A66 Northern Trans-Pennine project

Proposed changes consultation

January/February 2023

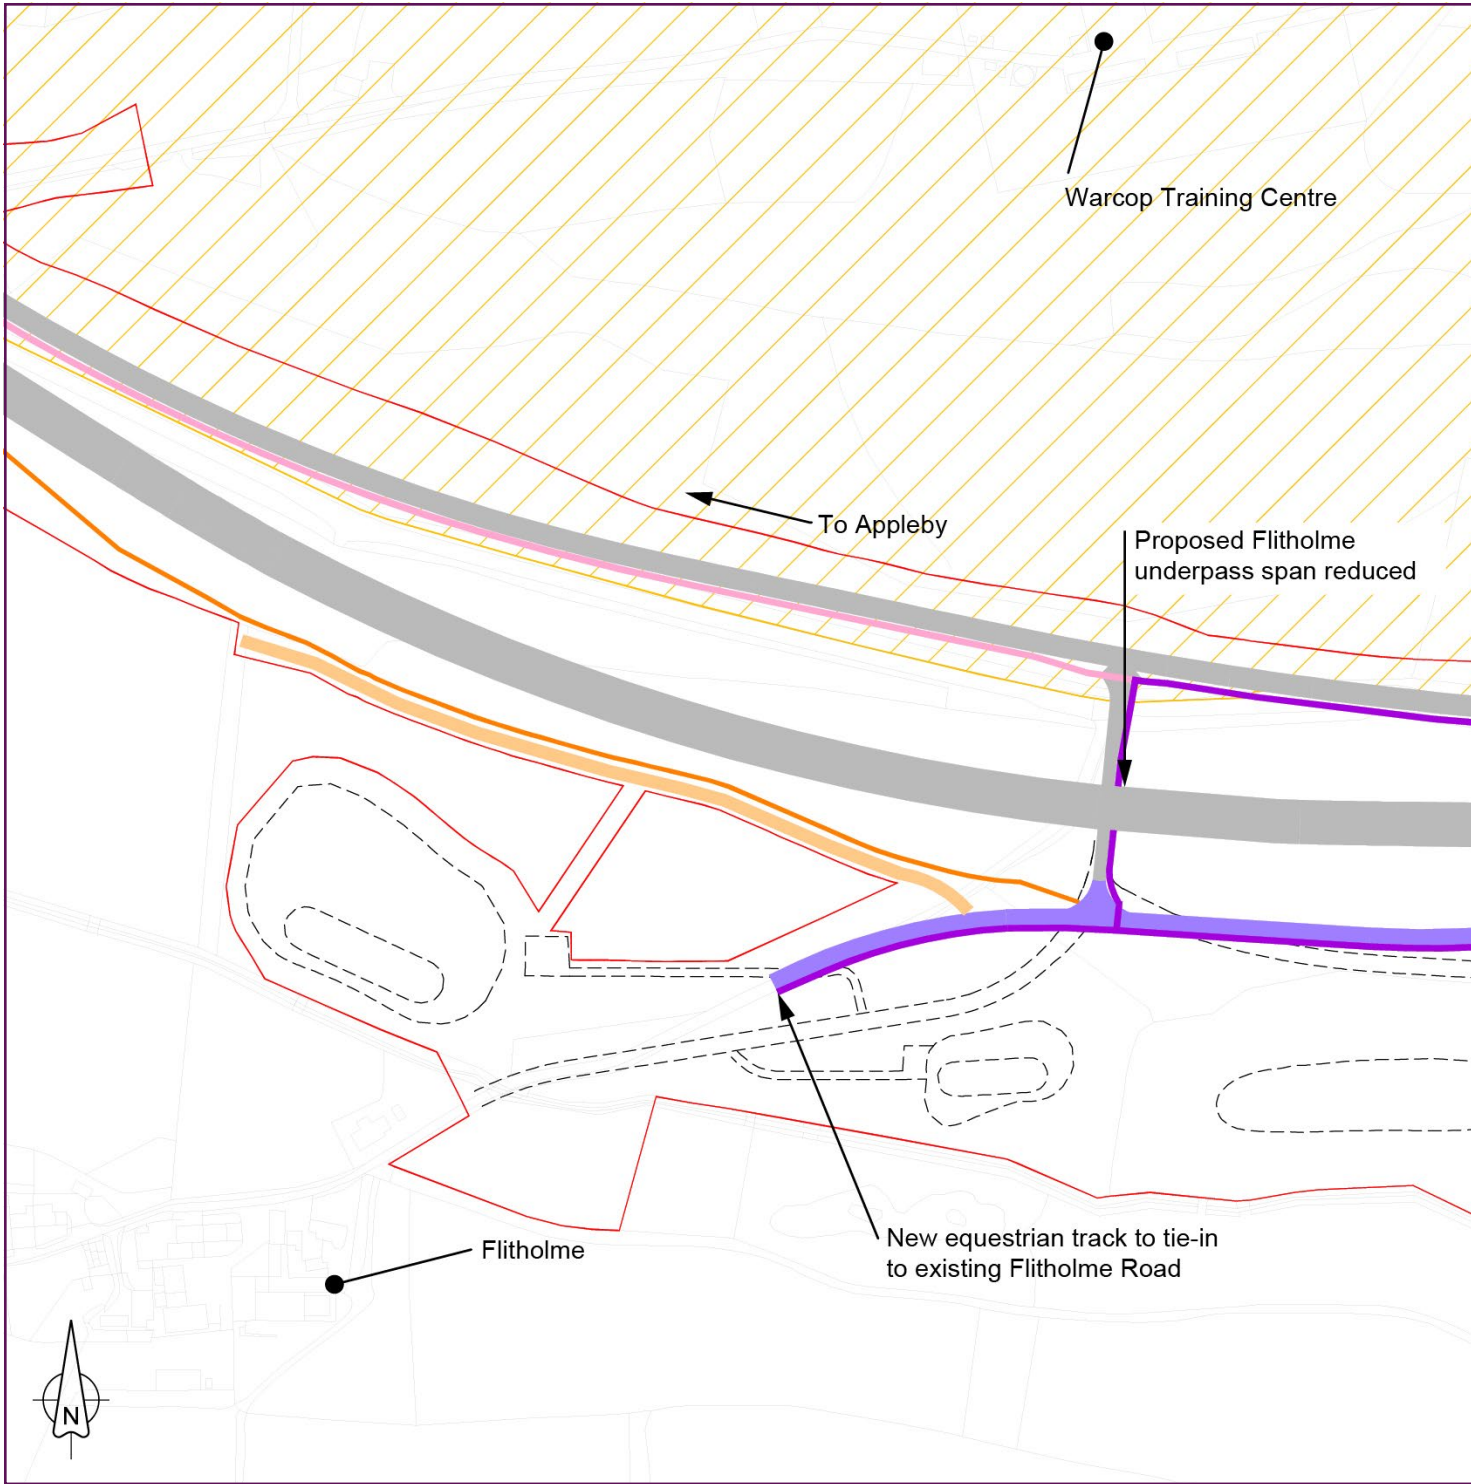
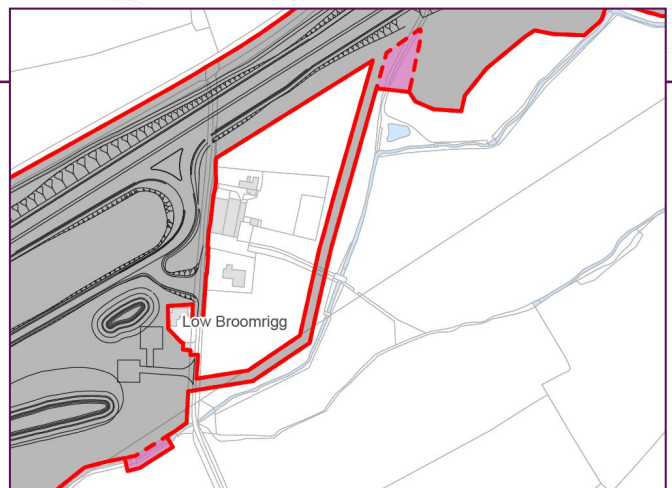
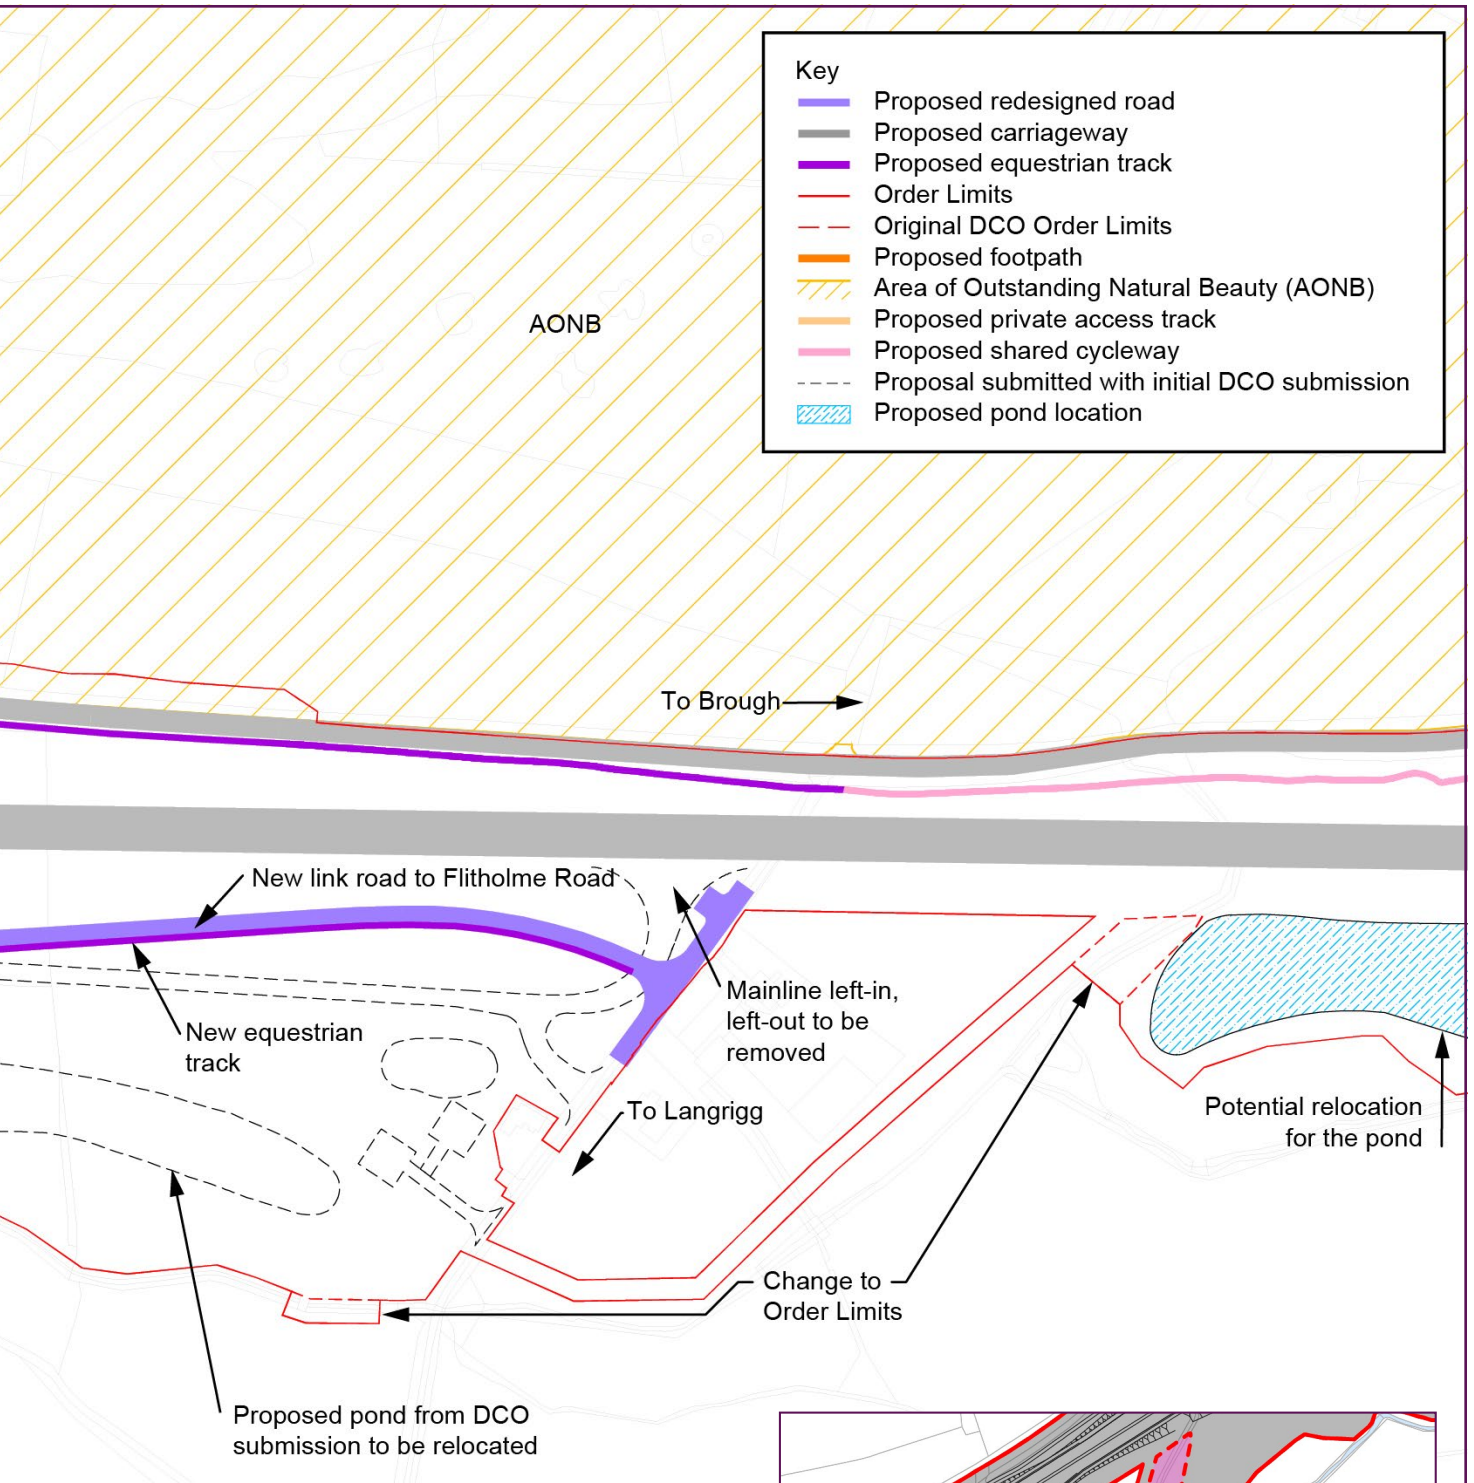
By tying in the Flitholme Road junction 100m to the north of the bridge over Lowgill Beck, we can also reduce impacts on residents in that area.

The removal of the Langrigg junction allows the link road and associated infrastructure to move north. The relocation of the largest balancing pond away from an area of fen, which is considered a priority habitat, provides the opportunity to reduce environmental

This plan helps to compare the DCO design with the proposed change at Langrigg. The DCO design is shown in dotted black with the proposed change (in principle) shown in colour. Further detailed design of aspects such as ponds and accesses continue to be developed.

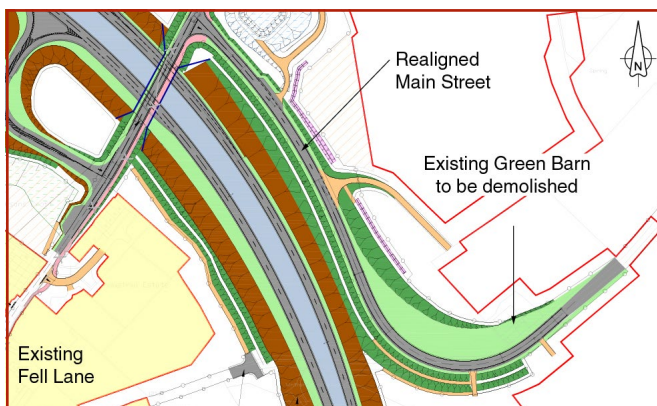
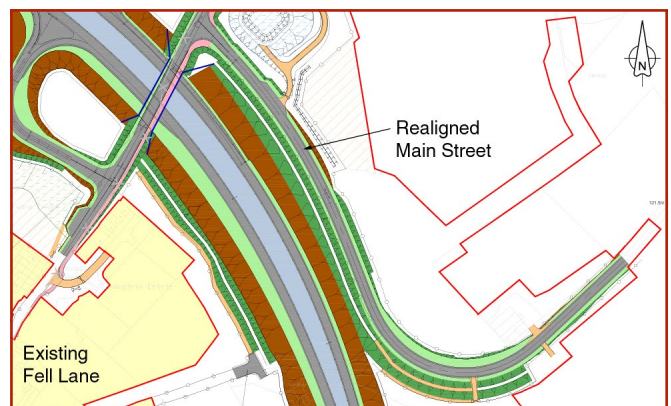
A change to the LoDs applying to the realignment of Main Street, to the east of Kirkby Thore, would enable us to remove a number of impacts on landowners and their premises.

This slight change to the realignment of Main Street would require a reduction in the speed limit to 30mph (from the existing 60mph limit, as retained in our DCO application) as vehicles approach the village. This reduction in speed enables the verge widths to be reduced as drivers will be travelling at a slower speed meaning that the visibility at the curve of the road can be reduced.

DC-23 – Realignment of de-trunked A66 to be closer to new dual carriageway at Warcop

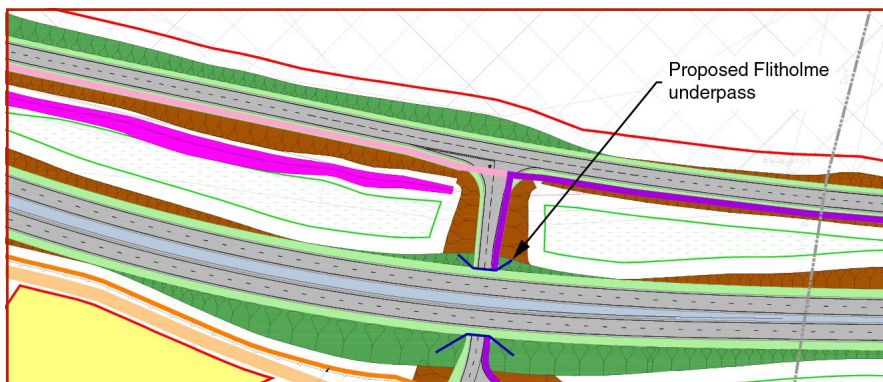
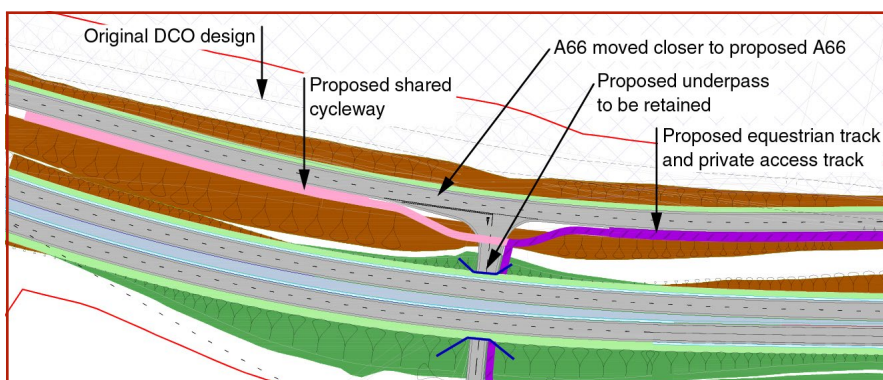
Our DCO proposes an underpass which leads under the new A66 road and onto the de-trunked section of the realigned old A66 to provide local access in both directions.

Currently the proposal is to rebuild the de-trunked section of the A66 to the north of the current road. A change to the LoDs applying to this would enable us to utilise more of the existing road. We would require a reduction in the speed limit to 30mph (from the existing 60mph limit, as retained in our DCO application) to achieve this on the de-trunked A66, which would bring it more in keeping with the local road network.

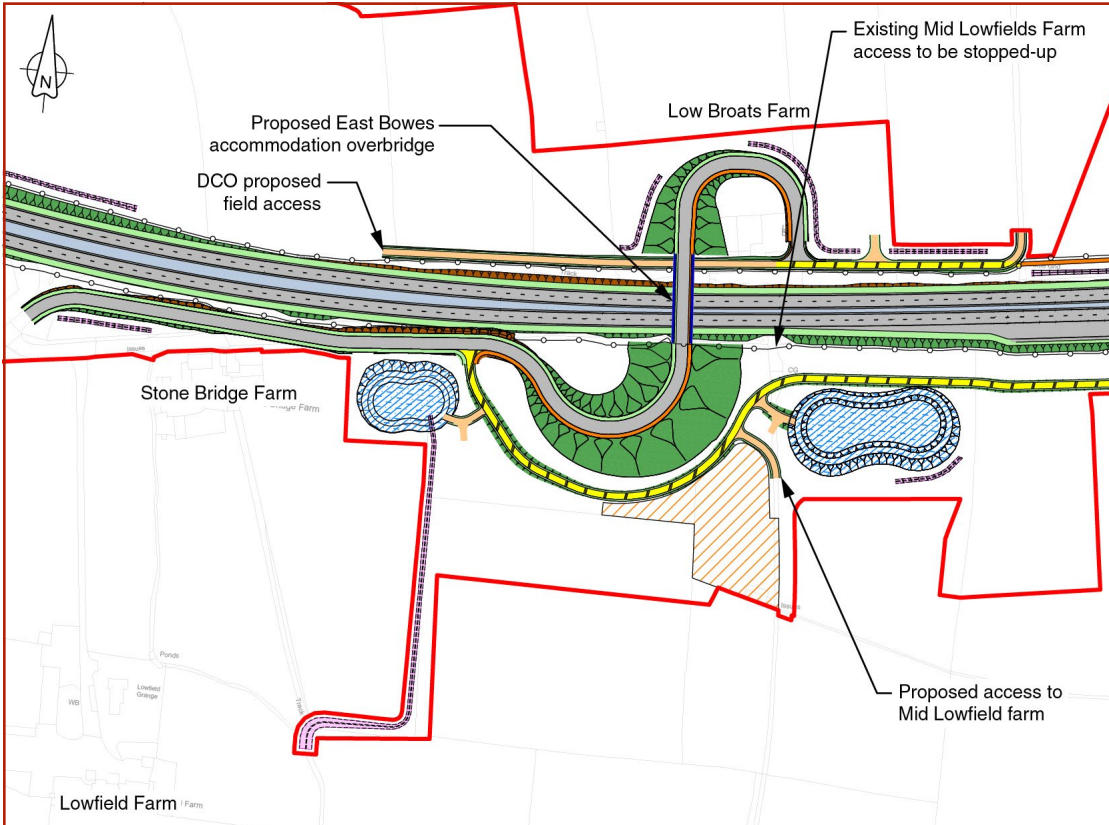
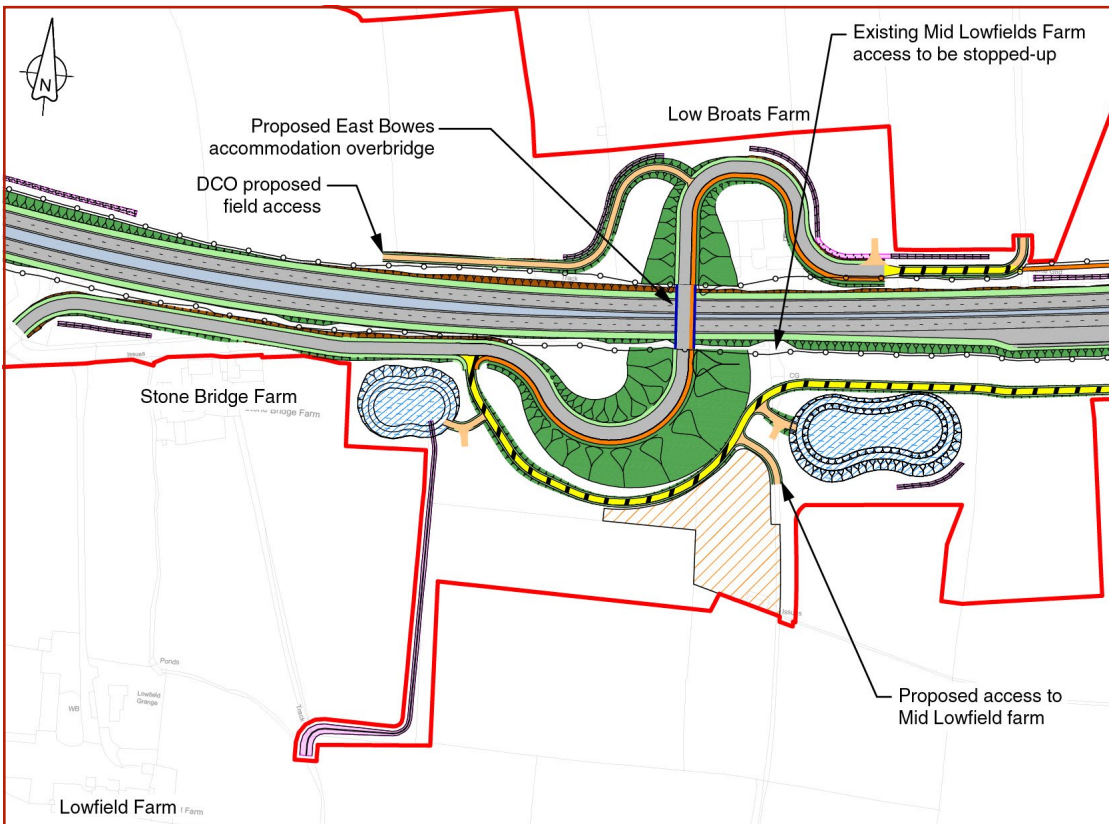
East of Bowes our DCO design includes separation between the dual carriageway and a private access track to help us build the road. Early detailed design has determined that this provision is no longer required. An increase in the lateral LoDs will enable the overbridge design to be simplified and moved closer to the dual carriageway.

As a result of the proposed change to the layout, a bridge over the A66, which carries a footpath and private access track, could be reduced in length by approximately 20m.
